MEMORANDUM

SUBJECT: Zoning Map Amendment No. G-832 (Garnkirk Farms/Duffie Property);
Reclassification from R-200 Zone to PD-11 Zone; Located northeast of
Gateway Center Drive on the north side of Shawnee Lane in Clarksburg

SUBJECT: Zoning Application No. G-832
Garnkirk Farms
Clarksburg

SUBJECT: 1. Preliminary Water Quality Plan for Garnkirk Farms Subdivision
2. Zoning Application No. G-832: Garnkirk Farms Subdivision

Figure 1

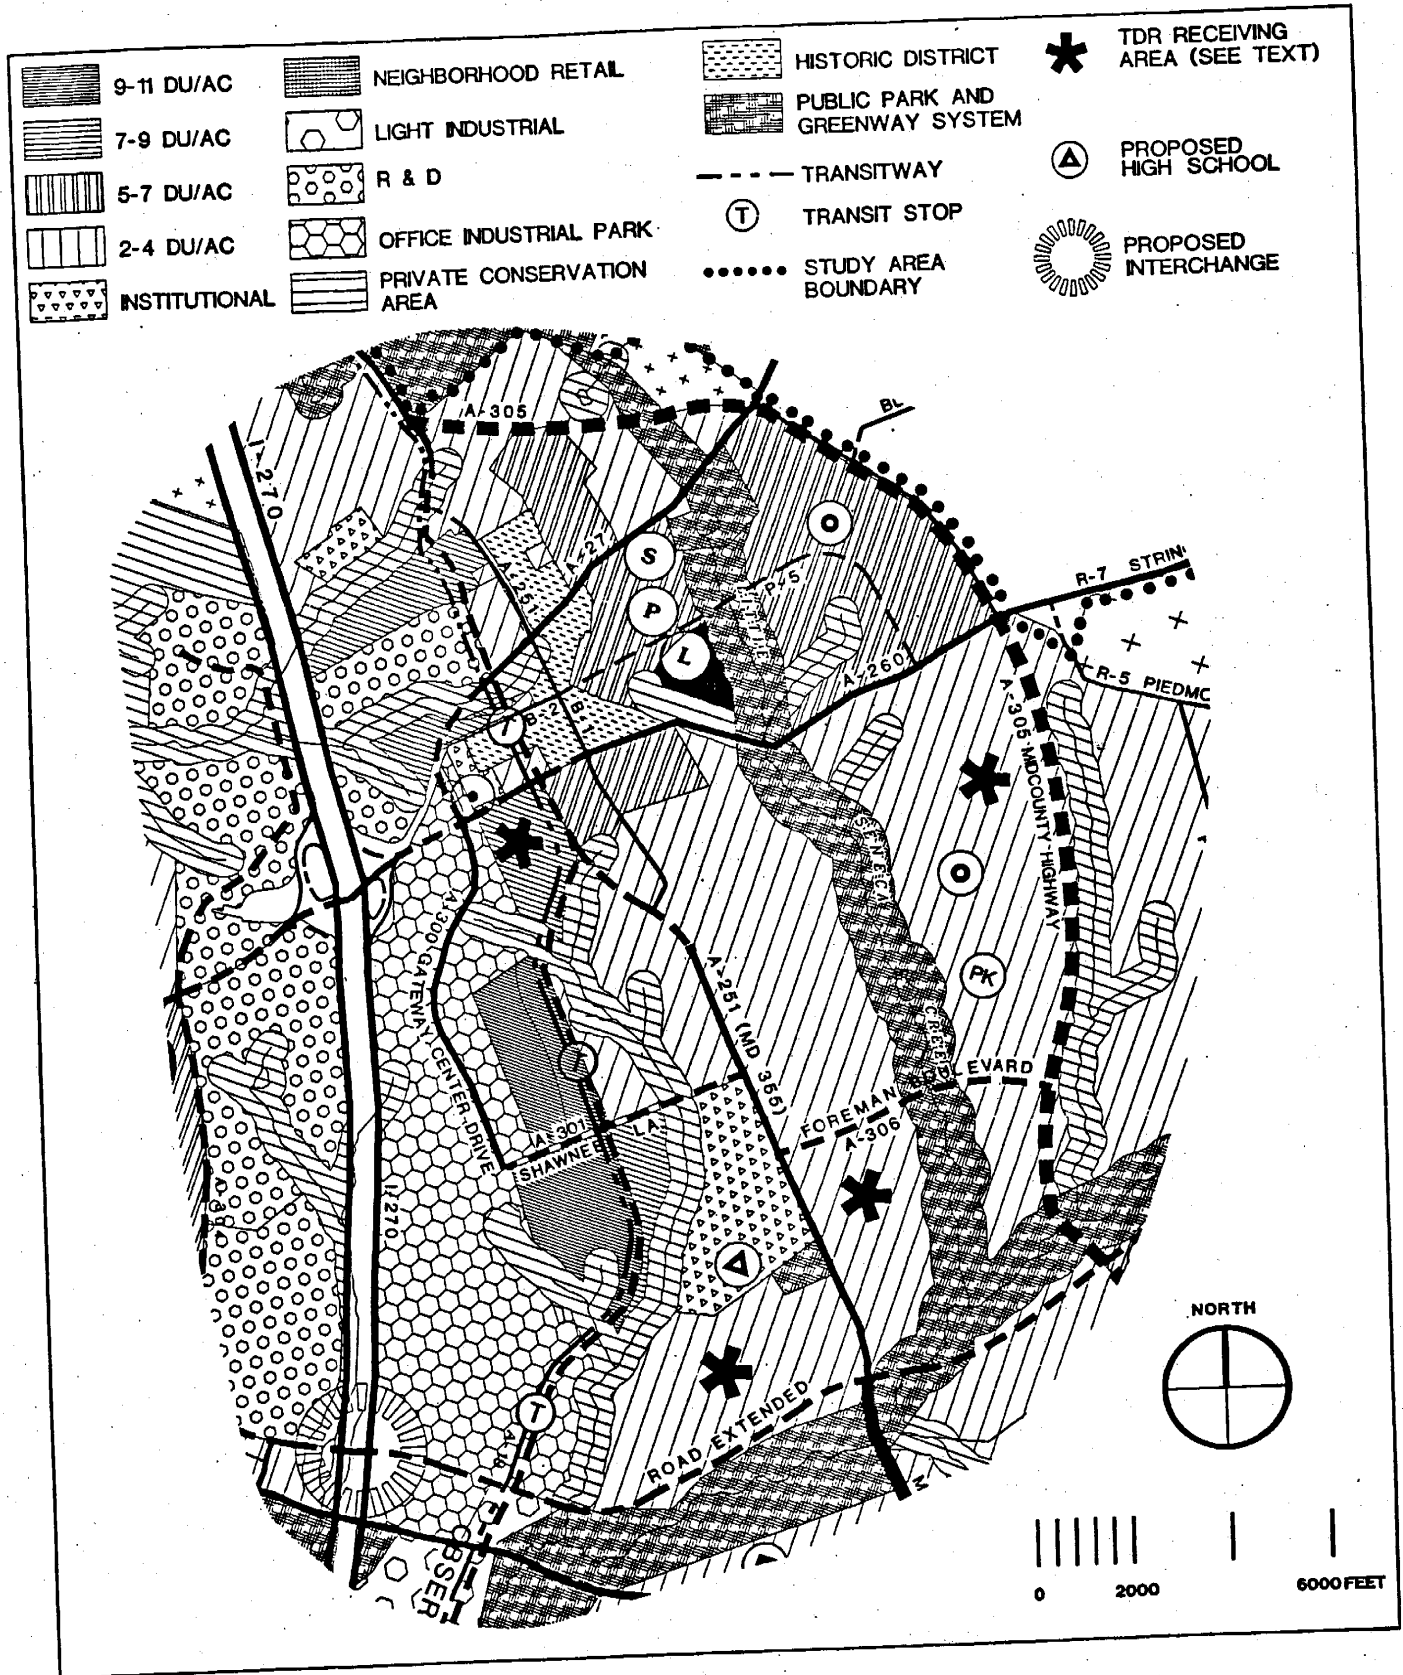
The Master Plan indicates that the alignment of Observation Drive in the vicinity of Shawnee Lane is along the eastern edge of the Duffie/Garnkirk Farm property as shown in Figure 1. This portion of Observation Drive also incorporates the Corridor Cities Transitway within a shared 150-foot wide right-of-way and a transit station at the Duffie property.
